Consultation Response (DC/25/1269)

Project:
Land North of Guildford Road, Rudgwick

Stage 1 Road Safety Audit

ROAD SAFETY AUDIT RESPONSE REPORT

Drawing:
1810054-09

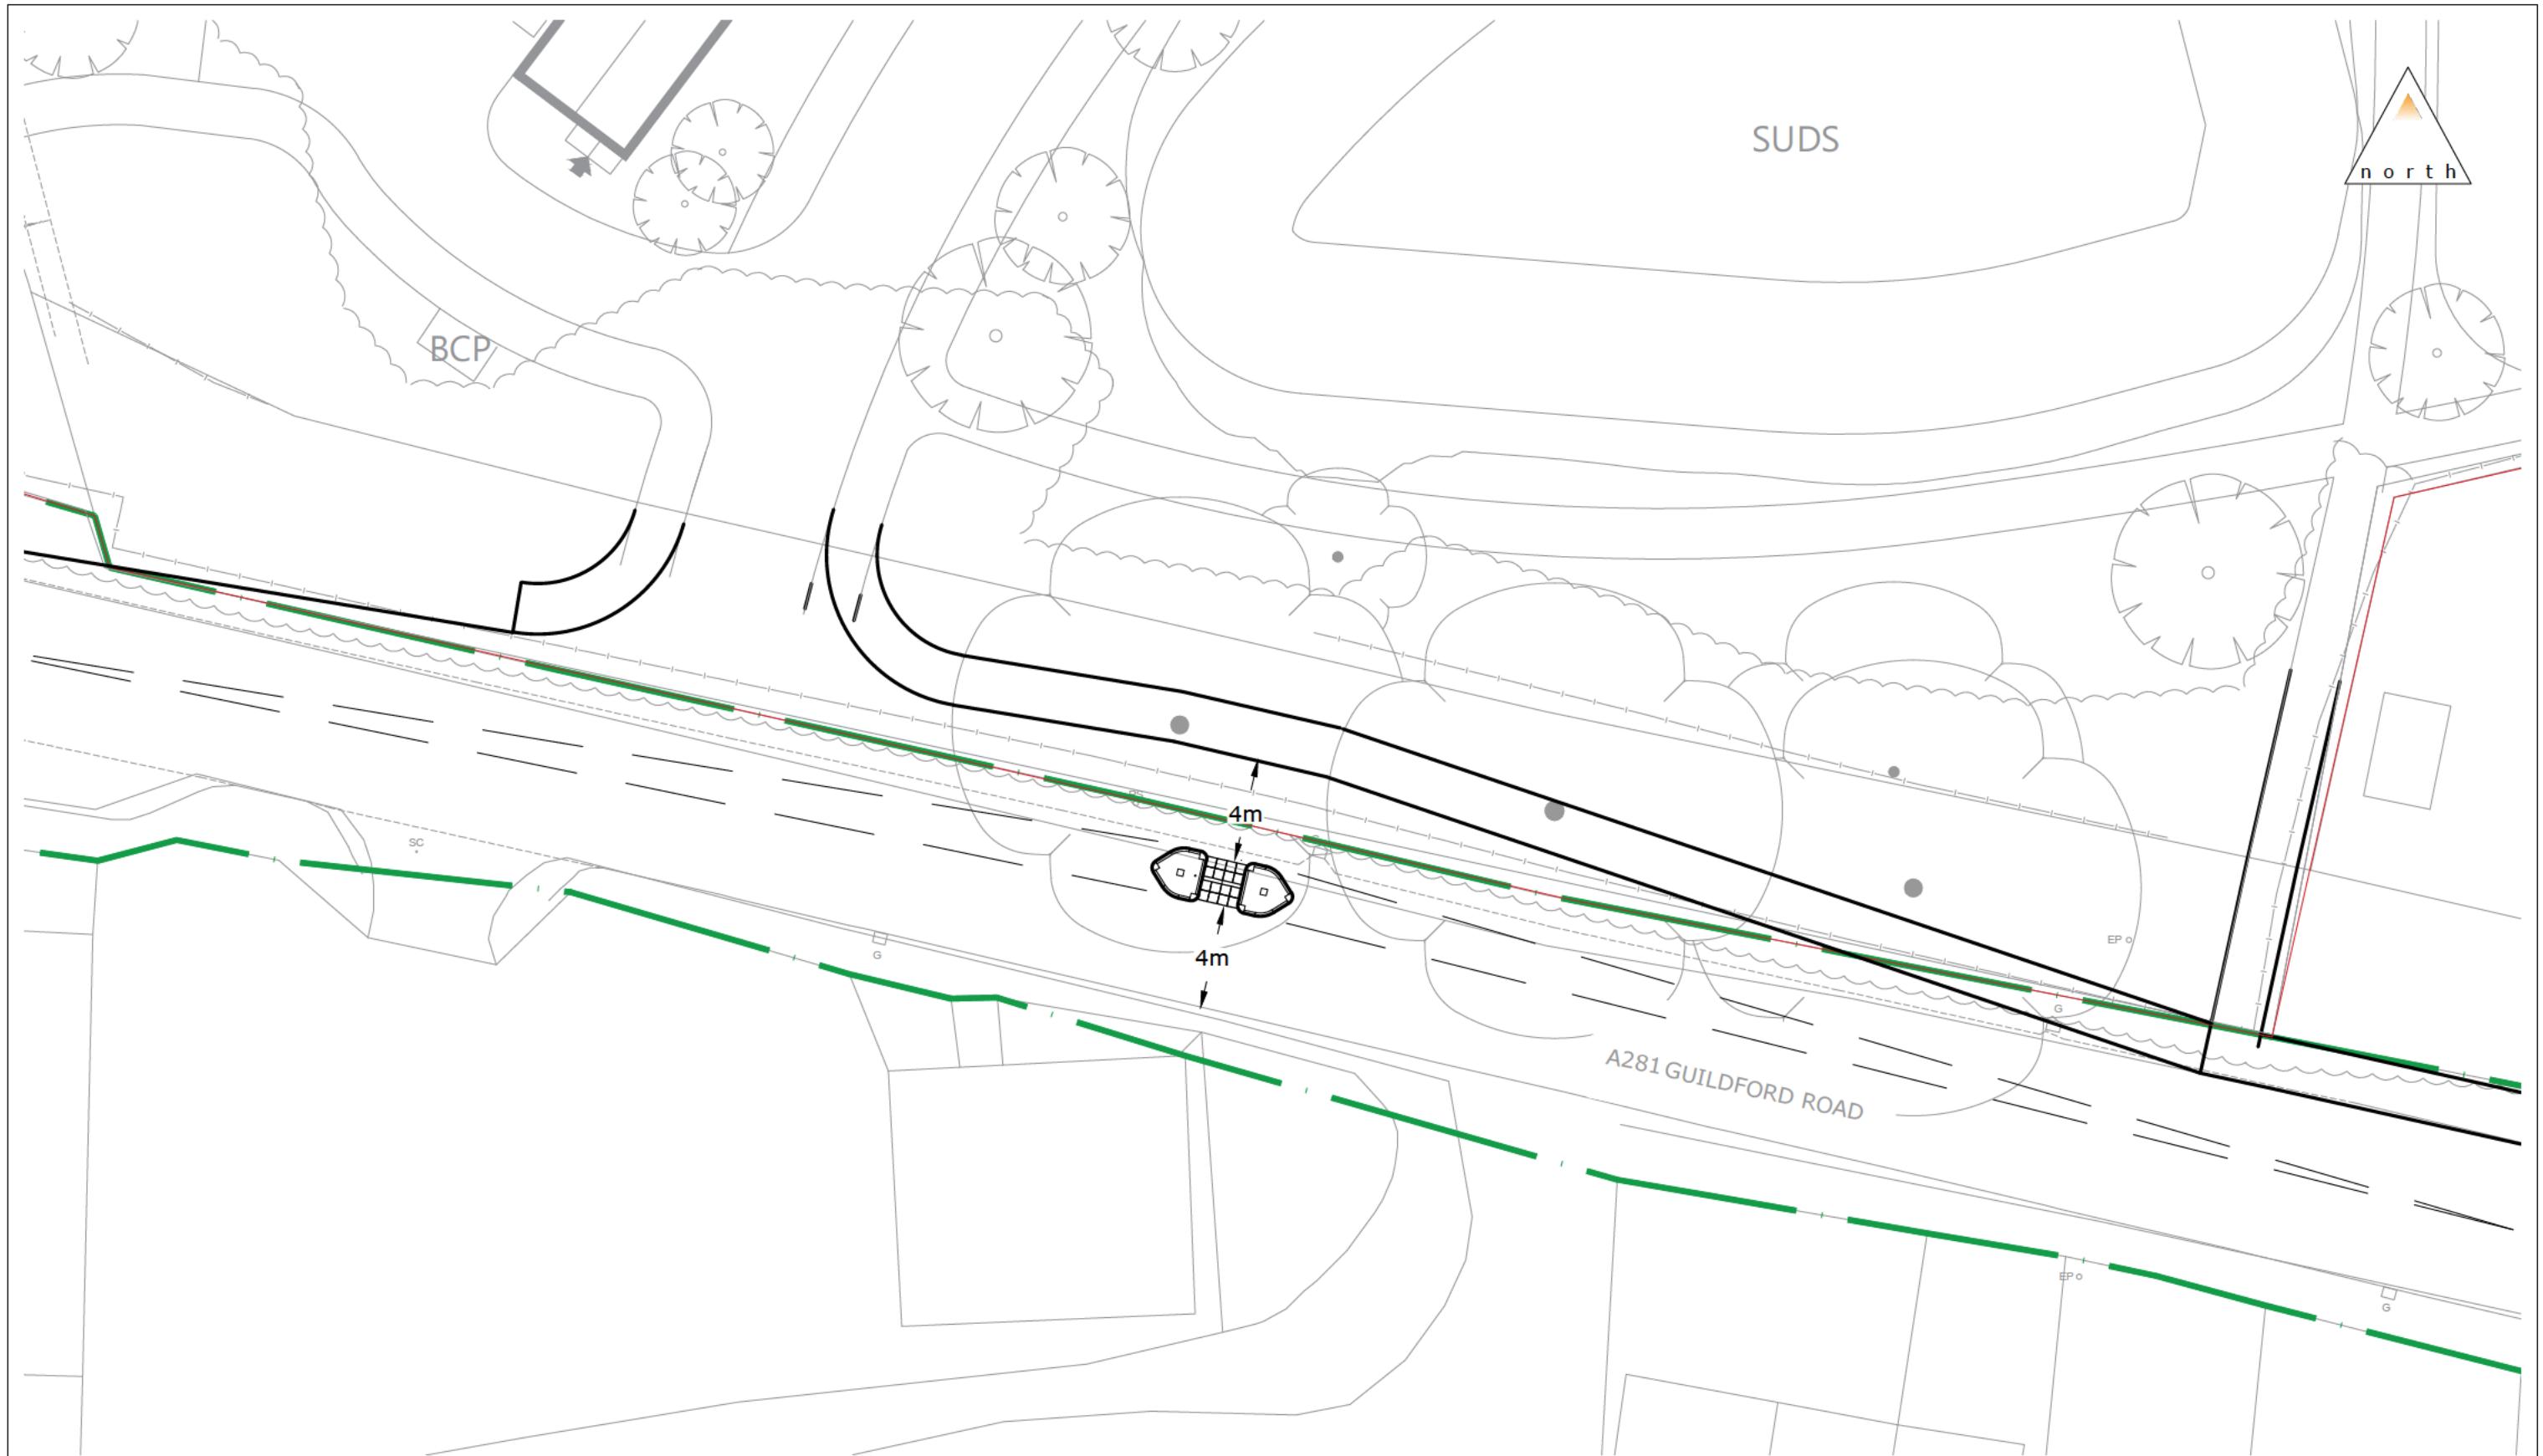
We have investigated the option of providing a central pedestrian crossing to assist pedestrians crossing the A218 to the east of the proposed access. A feasibility sketch is attached (1810054-09). You will see that the only position is mid-way along the frontage of the site between the site access and the eastern

end of the site positioned to accommodate the tracking requirements of exiting large vehicles from the site. Given the need to tie into the existing footway and carriageway at the eastern end of the site, it is necessary to use a 1 in 10 taper.

You will see that this feasibility layout is not practical in terms of the alignment of the eastbound through traffic lane. Additionally, it creates a small (substandard area) for right turning vehicles into the site access which is highly likely to lead to shunt collisions. It is also clear from the layout that it will have a significant impact on existing mature trees.

For these reasons, we are not intending to progress this arrangement.

APPENDIX B Location Plan(s)

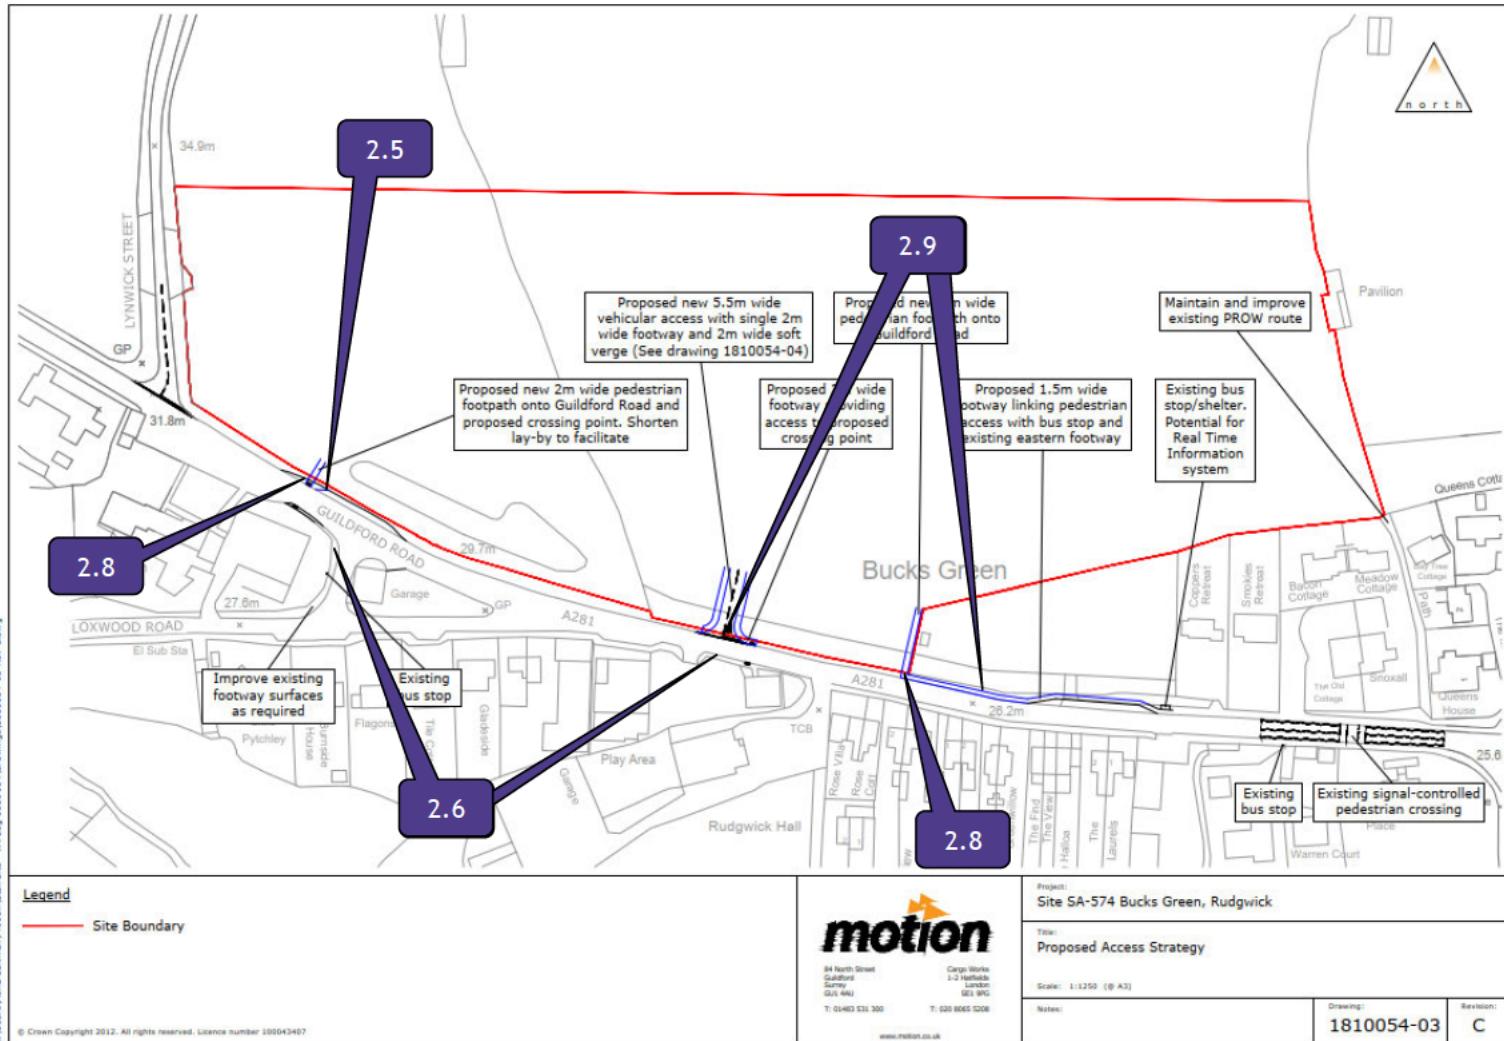
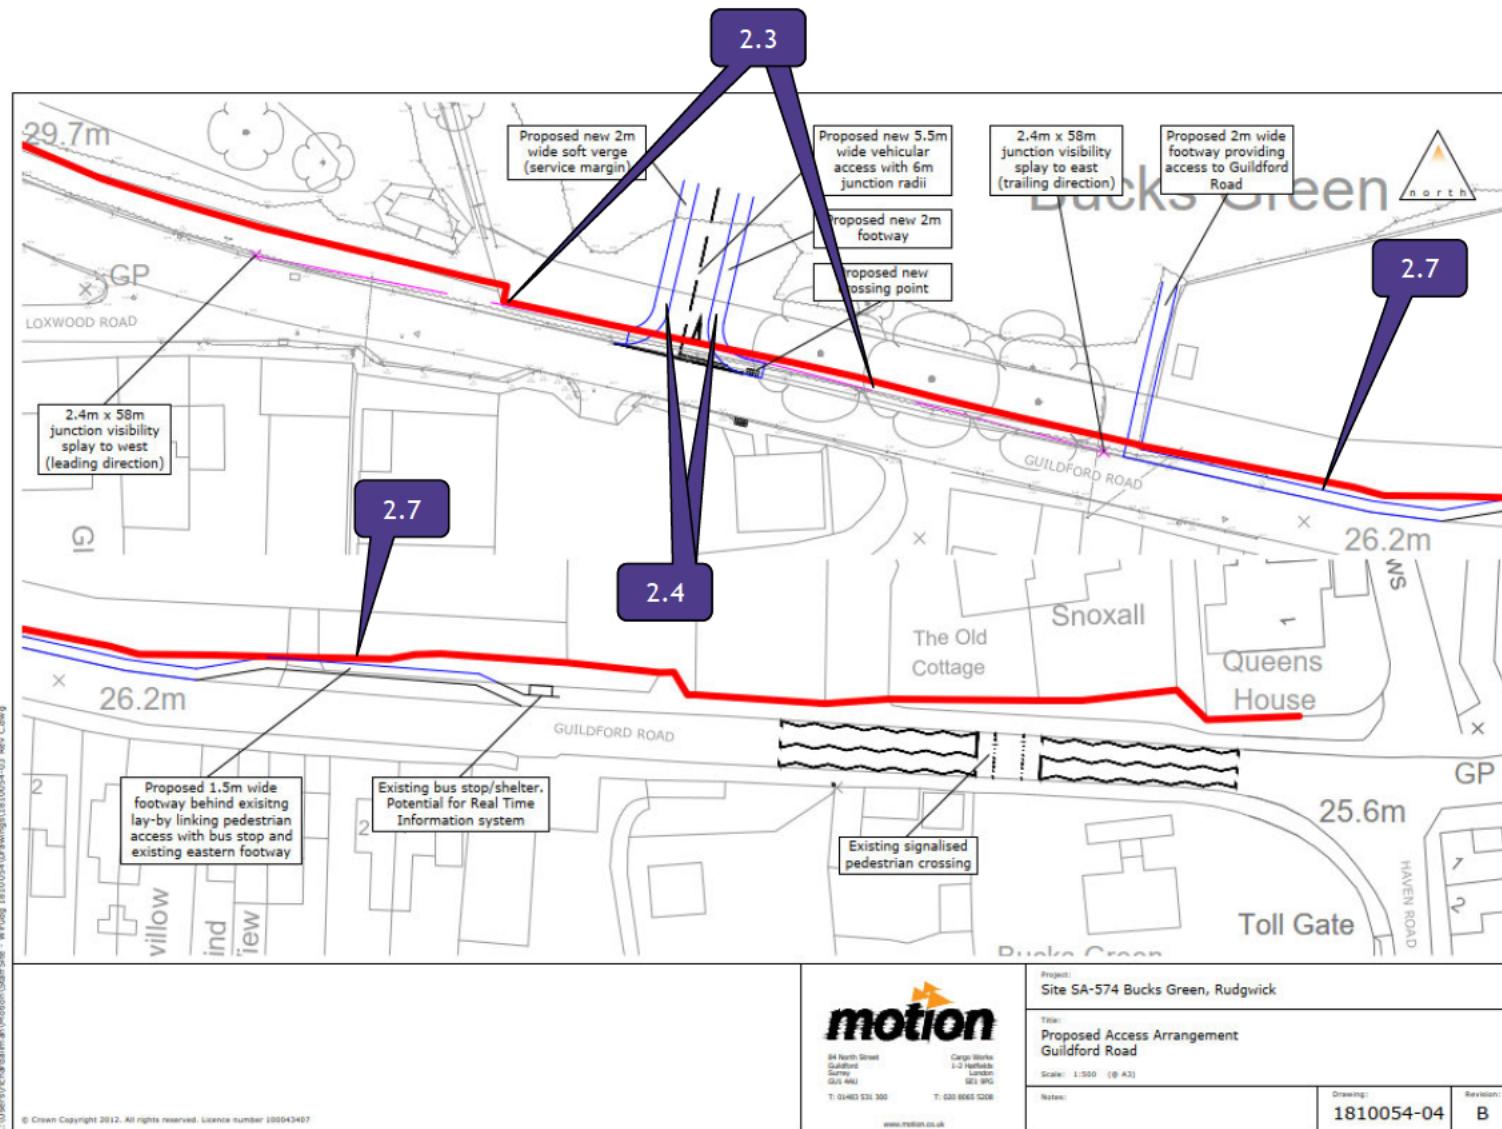
Potential vehicle collisions due to foliage/boundary treatments obscuring junction visibility.

It is not clear to what extent foliage will be removed to provide the junction visibility splays. It could in future grow back and obstruct visibility from the site access along Guildford Road, which could lead to vehicle turning collisions.

Absence of pedestrian facilities may lead to trips or falls.

No dropped kerbs or tactile paving are shown within the site access road. This could cause mobility or vision impaired pedestrians to trip or fall within the carriageway and potentially be struck by a moving vehicle.

Parking was observed within the lay-by on the north side of Guildford Road, immediately east of the proposed pedestrian crossing point. This restricts visibility between pedestrians and moving vehicles, which could lead to collisions.

The new crossings will encourage pedestrians to use the existing footway along the south side of Guildford Road, which is uneven and may cause pedestrian trip/fall injuries.

It is not clear to what extent foliage adjacent to the new footway will be removed. It could encroach and force pedestrians to walk along the carriageway or within the bus lay-by, where they will be at risk of collision with passing vehicles, particularly at night.

The proposed footpath connections from the development site are perpendicular to Guildford Road and pedestrians emerging from the development may enter the carriageway without due care, leading to pedestrian/vehicle collisions or rear/front (shunt) type collisions between vehicles due to hard braking.

Guildford Road appears poorly lit. The likely increase in pedestrian and traffic movements arising from the development could increase the risk of night-time vehicle/pedestrian or vehicle turning collisions.

Cut back foliage with sufficient clearance behind the junction visibility splays to minimise future maintenance and limit the risk of obstruction to the emerging driver's view.

Provide dropped kerbs and tactile paving for pedestrians wishing to cross the site access road, north of Guildford Road.

Introduce measures to prevent parking at the proposed pedestrian crossing, providing suitable pedestrian/vehicle inter-visibility.

The sections of footway (a) connecting Guildford Road and Loxwood Road, on the east side of The Fox Inn, and (b) opposite the site access, should be resurfaced.

Cut back foliage with sufficient clearance behind and above the proposed footway to minimise future maintenance and limit the risk of obstructing pedestrians.

A short section of guard railing should be provided opposite the footpath to prevent pedestrians from entering the crossing injudiciously. Alternatively, design the footpath alignment avoiding a straight, perpendicular approach.

At the detailed design stage assess lighting levels at the junction and on the footway and, if appropriate, provide street lighting along Guildford Road.

2.4	Provide dropped kerbs and tactile paving for pedestrians wishing to cross the site access road, north of Guildford Road.	Dropped kerbs and tactile paving will be provided, this will be considered further at the detailed design stage.	No comment required.	Dropped kerbs and tactile paving to be provided at pedestrian crossing points.

2.5	Introduce measures to prevent parking at the proposed pedestrian crossing, providing suitable pedestrian/vehicle inter-visibility.	Agreed, a measure will be considered at the detailed design stage.	Whilst the problem and subsequent Design Team response are noted, WSCC recommend that this crossing is removed from the proposals. This is due to the potential for visibility to be obstructed to the east by parked cars and to the west by the vertical alignment of the carriageway.	The proposed western pedestrian crossing point is to be removed.

2.6	The sections of footway (a) connecting Guildford Road and Loxwood Road, on the east side of The Fox Inn, and (b) opposite the site access, should be resurfaced.	Agreed, this will be discussed and considered further at the detailed design stage.	Improvements to the footway surfacing is noted on the submitted drawings that will be secured by condition.	Surfacing improvements are to be secured by condition.

2.7	Cut back foliage with sufficient clearance behind and above the proposed footway to minimise future maintenance and limit the risk of obstructing pedestrians.	Agreed, foliage to be cut back. Site clearance drawings will be prepared at the detailed design stage.	The Applicant is to cut back any vegetation encroaching into the proposed footway. Once constructed, WSCC will thereafter inspect and undertake maintenance of the footway.	The Applicant is to cutback vegetation as necessary ahead of the footway being constructed. WSCC will thereafter inspect and undertake maintenance as required.

RSA Decision Log				
Item No.	RSA Recommendation	Design Organisation Response	Overseeing Organisation Comments	Agreed RSA Action
2.8	A short section of guard railing should be provided opposite the footpath to prevent pedestrians from entering the crossing injudiciously. Alternatively, design the footpath alignment avoiding a straight, perpendicular approach.	Agreed, a drawing will be prepared at the detailed design stage detailing the location of the guardrail.	The provision of guard railings are noted.	Details of guard railings are to be provided and agreed as part of the detailed design.

2.9	At the detailed design stage assess lighting levels at the junction and on the footway and, if appropriate, provide street lighting along Guildford Road.	Noted.	The Applicant is to undertake a suitable assessment of street lighting as part of the detailed design and as necessary upgrade street lighting within the immediate vicinity of the site in accordance with current WSCC Street Lighting standards.	The Applicant is to undertake a suitable assessment of street lighting as part of the detailed design and as necessary upgrade street lighting within the immediate vicinity of the site in accordance with current WSCC Street Lighting standards.
